City of Rialto

Legislation Details (With Text)

For Transportation Commission Meeting [November 3, 2021]

Traffic Impact Analysis - Foothill Apartment TIA - 534 Foothill Boulevard (ACTION ITEM)

Exhibit 4.12 - Street Section

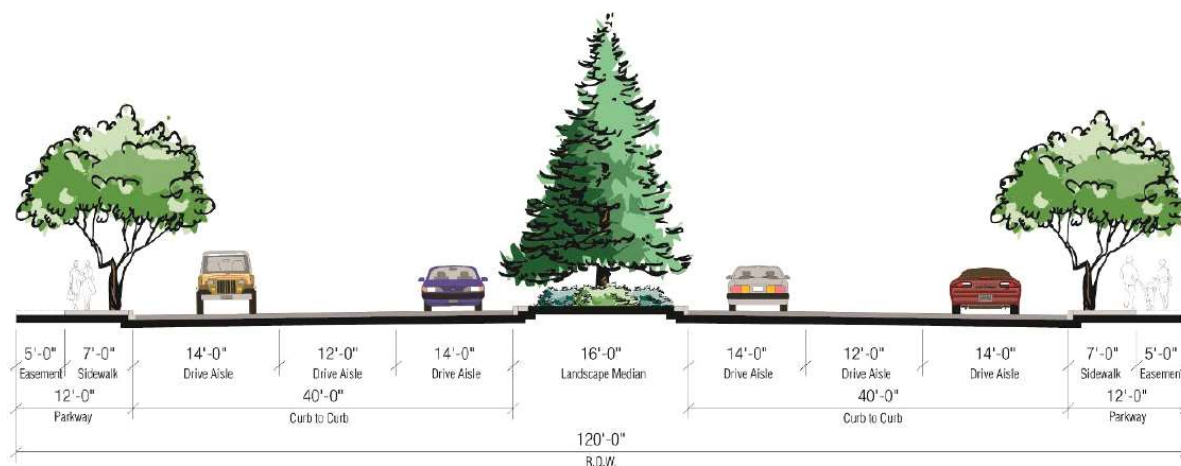
In addition to access configuration, it is recommended that the Project construct Foothill Boulevard at its ultimate half-width as a Modified Major Arterial I (120-foot right-of-way) from the western Project boundary to the eastern Project boundary consistent with the City's standards. This will meet the requirements of the Foothill Boulevard Specific Plan as shown below:

- Provide recommendations related to approval.
- Recommend improvement of Foothill Boulevard along the project frontage to full half-width of 120' consistent with a Modified Major Arterial I (120-foot right-of-way) consistent with City Standards including median improvements or access restrictions/improvements subject to the satisfaction of the City Engineer with final configuration to be determined during final design.
- Recommend payment of applicable DIF fees.
- Recommend no payment of Fair Share fees.
- Recommend approval to the Planning Commission.
